Contract #: 04-0120F4Cty: SF/ALA Rte: 80 PM: 13.2/13.9File #: 69.25B**QUALITY ASSURANCE -- NON-CONFORMANCE REPORT****Location:** Changxing Island, Shanghai, P.R. China**Report No:** NCR-000457**Prime Contractor:** American Bridge/Fluor Enterprises, a JV**Date:** 24-Sep-2009**Submitting Contractor:** Zhenhua Port Machinery Company, Ltd (ZPMC), Changxing Island**NCR #:** ZPMC-0430**Type of problem:**

Reference Description: Cold bending of SPCM Member: Crossbeam 14 Intermediate Web Plate CB202E**Description of Non-Conformance:**

Subject: NCR No. ZPMC-0430

Project Name: S.F.O.B.B 项目名称: 美国加州海湾大桥		NCR Number: NCR 编号: NCR-B- 290 ²⁹⁰ (ZPMC- 0430 ⁰⁴³⁰)	
Item: Cold bending of SPCM 名称描述: 对 SPCM 板冷弯		Item Number: 件号: N/A	Drawing: CB14 图号:
Location: Bay 2 位置: 2 车间		Date: 日期: 2009-11-05

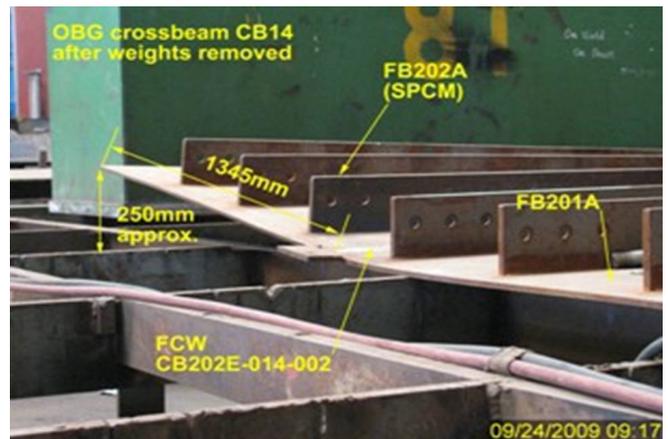
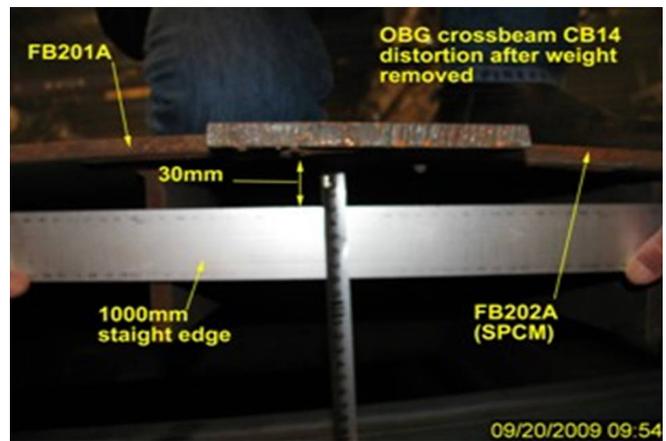
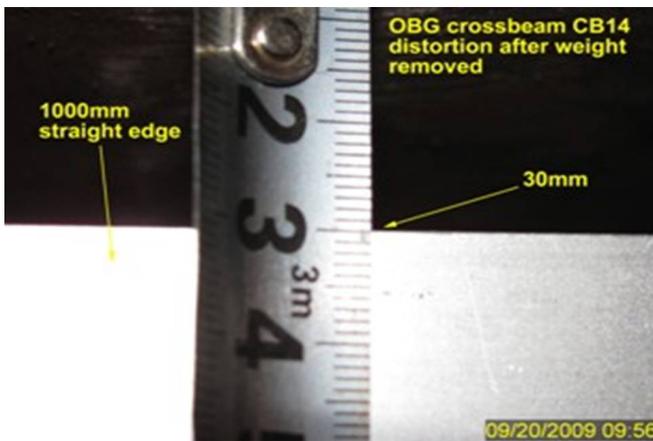
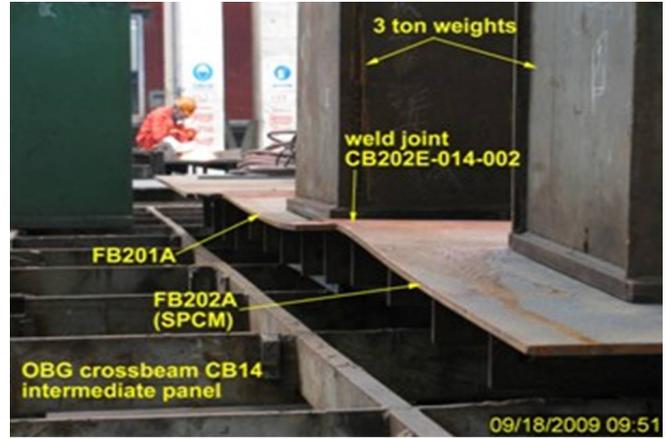
On Sept. 18, 2009, this Quality Assurance Inspector (QA) observed that the contractor performed "cold bending" of the Seismic Performance Critical Material (SPCM) and a Fracture Critical Weld (FCW). This QA observed two (2) three (3) ton weights had been placed on the material, one on each side of the FCW. The weights appeared to be for the purpose of bending the material. The SPCM is identified as FB202A. The FCW joint is identified as CB202E-014-002. See attached photos for details.

On Sept. 20, 2009, this Quality Assurance Inspector (QA) observed that the contractor performed "cold bending" Seismic Performance Critical Material (SPCM) and a Fracture Critical Weld (FCW). The QA inspector observed one (1) three (3) ton weight had been placed on the material near the FCW. The weight appeared to be for the purpose of correcting excessive weld distortion of the base metal material. The SPCM material is identified as FB202A and the FCW weld joint is identified as CB202E-014-002.

On Sept. 24, 2009, this Quality Assurance Inspector (QA) observed that the contractor performed "cold bending" Seismic Performance Critical Material (SPCM) and a Fracture Critical Weld (FCW). This QA observed two eight (8) ton weights had been placed on the material near the FCW. The weights appeared to be for the purpose of correcting excessive weld distortion of the material. The SPCM is identified as FB202A and the FCW joint is identified as CB202E-014-002.

AWS D1.5 2002 section 12.12 "Cold bending shall be prohibited for all fracture critical steels."

Submit a repair procedure to the engineer for approval and discontinue any further cold bending on similar members.

ZPMC had an approved heat straightening request but it was not on site at the time of the heat straightening. ZPMC has educated the production team to ensure that they have the paperwork on site before they begin work. ZPMC has included NDT documentation of the weld to show that it is sound. Based on this ZPMC requests closure of this NCR.

The documentation submitted has been reviewed by the Engineer and is found to be acceptable.

Reference Description: Cold bending of SPCM Member: Crossbeam 14 Intermediate Web Plate CB202E

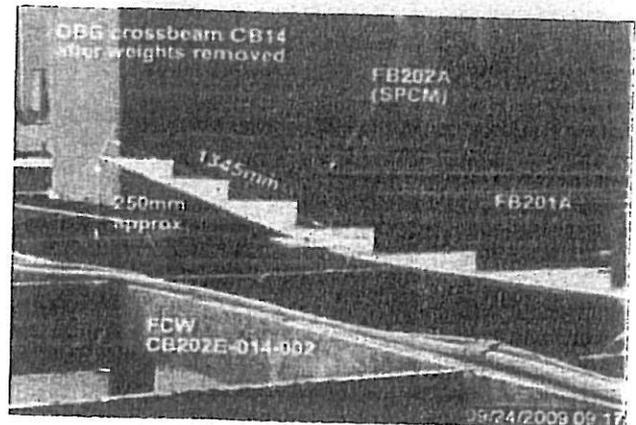
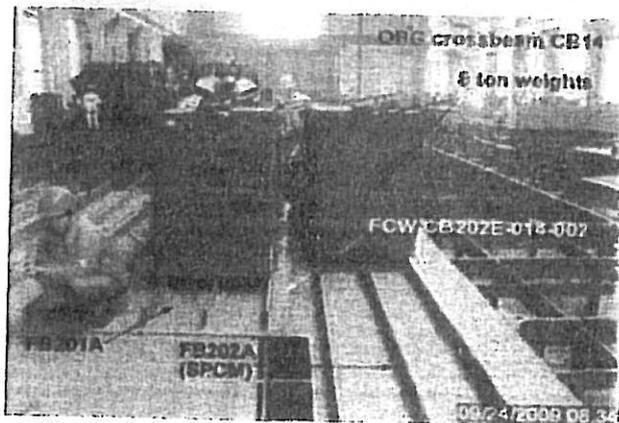
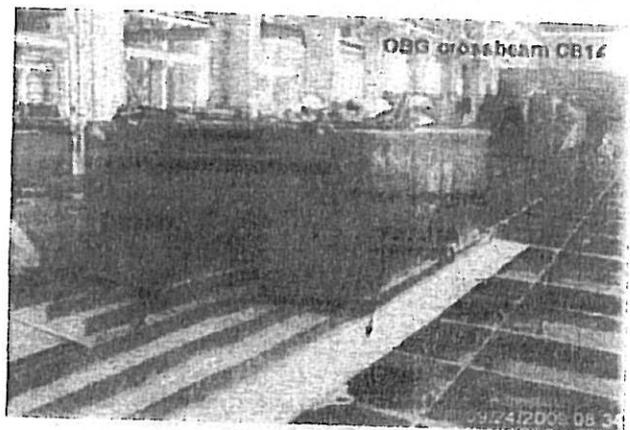
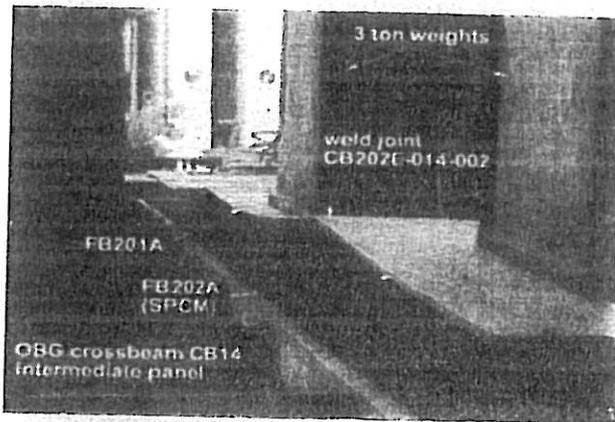
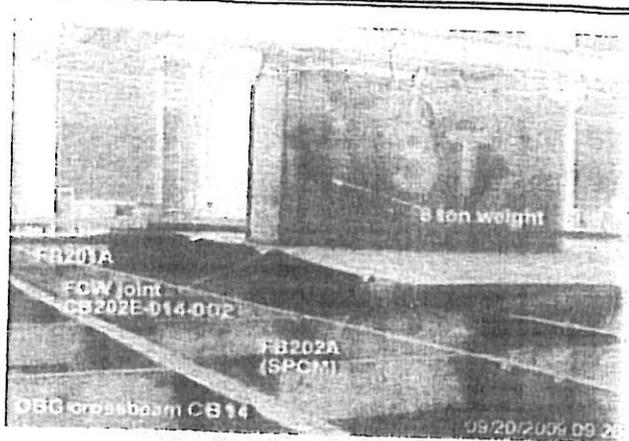
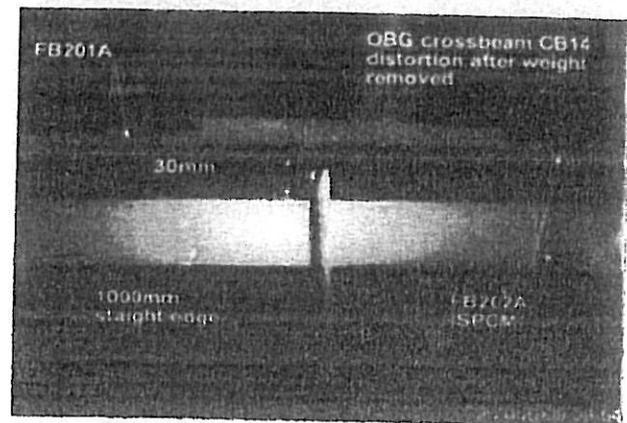
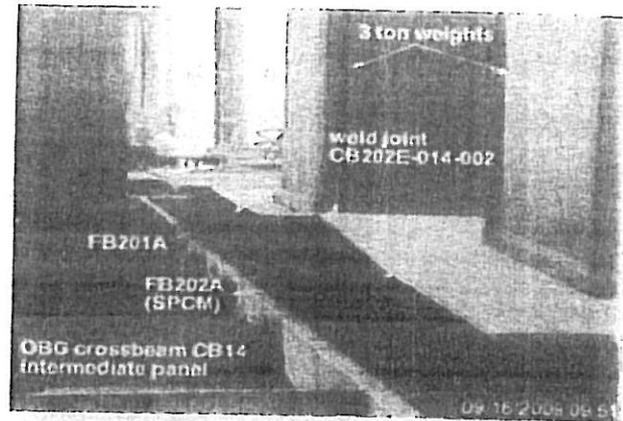
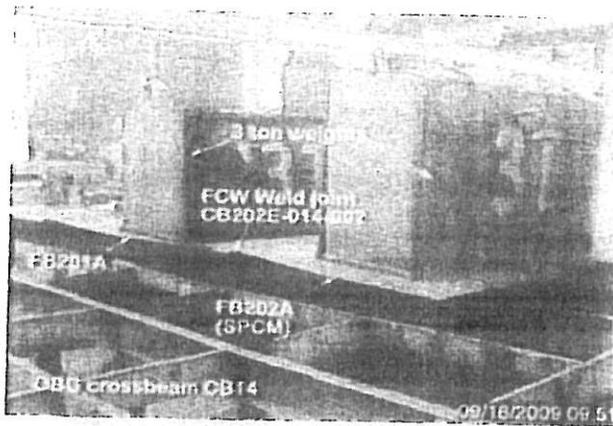
On Sept. 18, 2009, this Quality Assurance Inspector (QA) observed that the contractor performed "cold bending" of the Seismic Performance Critical Material (SPCM) and a Fracture Critical Weld (FCW). This QA observed two (2) three (3) ton weights had been placed on the material, one on each side of the FCW. The weights appeared to be for the purpose of bending the material. The SPCM is identified as FB202A. The FCW joint is identified as CB202E-014-002. See attached photos for details.

On Sept. 20, 2009, this Quality Assurance Inspector (QA) observed that the contractor performed "cold bending" Seismic Performance Critical Material (SPCM) and a Fracture Critical Weld (FCW). The QA inspector observed one (1) three (3) ton weight had been placed on the material near the FCW. The weight appeared to be for the purpose of correcting excessive weld distortion of the base metal material. The SPCM material is identified as FB202A and the FCW weld joint is identified as CB202E-014-002.

On Sept. 24, 2009, this Quality Assurance Inspector (QA) observed that the contractor performed "cold bending" Seismic Performance Critical Material (SPCM) and a Fracture Critical Weld (FCW). This QA observed two eight (8) ton weights had been placed on the material near the FCW. The weights appeared to be for the purpose of correcting excessive weld distortion of the material. The SPCM is identified as FB202A and the FCW joint is identified as CB202E-014-002.

AWS D1.5 2002 section 12.12 "Cold bending shall be prohibited for all fracture critical steels."

Submit a repair procedure to the engineer for approval and discontinue any further cold bending on similar members.

Contractor submitted Heat Straightening Report as well as NDT reports verifying the welds are in conformance with Contract specifications.

Heat Straightening Report(HSR)

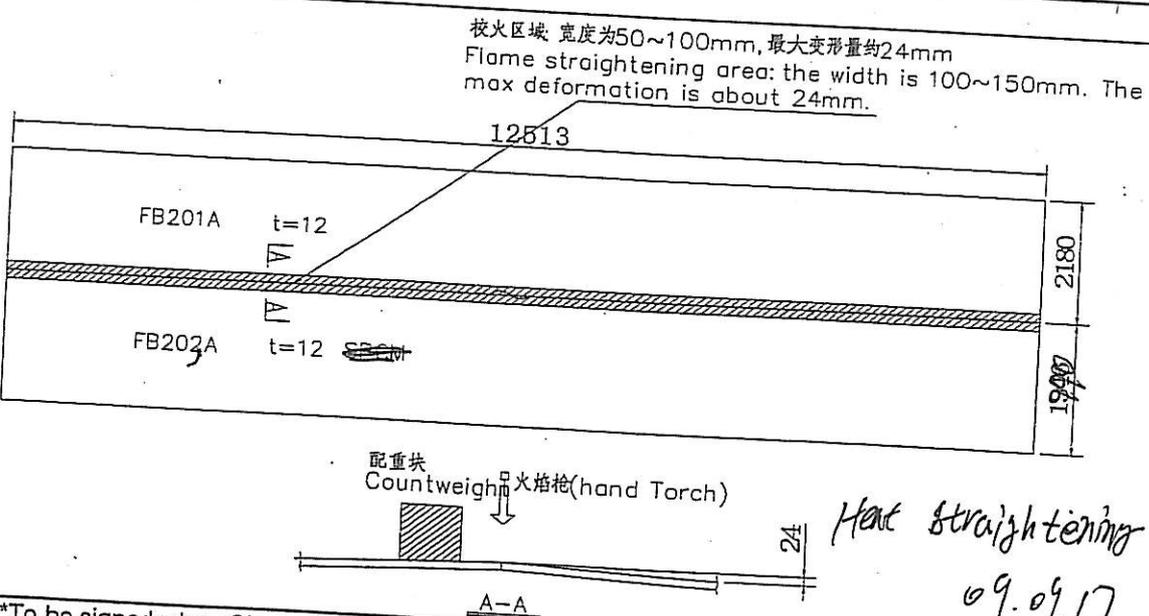
情况描述 Description of Condition

Cause原因 Welding distortion 焊接变形

Type of Defect缺陷类型 Welding distortion 焊接变形

缺陷去除方法(Defect Removal Method): Flame Straightening by oxygen acetylene 运用氧乙炔进行校火

后续NDE(Post-Removal NDE): After finishing heat straightening, the weld of the heat area shall perform NDT according to the approved shop drawing 校火后, 根据图纸要求对热影响区域进行NDT检测.
Control current, voltage and weld speed according to relevant WPS. If necessary anti-deformation or hold down device can be added. 依据相应的WPS的要求控制电流, 电压和焊接速度. 如有必要, 可使用反变形设施进行校正.

实施次数(Number of application): 1~3

最高温度(Maximum temperature): <600°C
